MEMORANDUM

From:	Catherine Brimble Senior landscape Officer		
Service	SDL Landscape and Trees	App No:	242653
Address:	Hogwood Farm, Sheerlands Road, Arborfield, Wokingham, RG40 4QY.		
Proposal:	Full application for the proposed erection of 48 residential dwellings with associated access, internal roads, parking, landscaping, drainage and cycle storage.		
Type of Development:	Major Dwellings (10+)		
Site Visit Made:	Yes/No

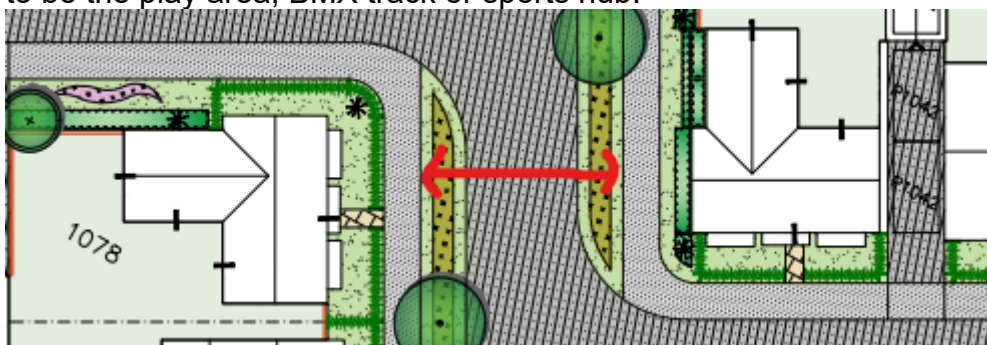
I have the following comments to make regarding the layout:

- The DAS references the design process with option 4 being the preferred option and the basis for the submitted layouts in relation to this application. A number of reasons were given including the incorporation of a 20m buffer along the entire eastern boundary to provide a strong green edge. The layout as provided does incorporate a landscape buffer, however this is not the 20m as originally identified. The proposed buffer along the eastern edge of the housing development ranges from 7.4m – 14m reducing where the width is constricted due to the four parking bays encroaching into this area. I would have expected this area to be wider and suggest a reduction in the number of visitor spaces.

- The layout will need to incorporate a pedestrian link from the residential parcel to the bridleway and the proposed play area beyond. The best location for this

connection to avoid existing offsite vegetation and a major level change will be where the current visitor spaces are located on the western boundary as shown below. The layout will be amended to show this pedestrian connection.
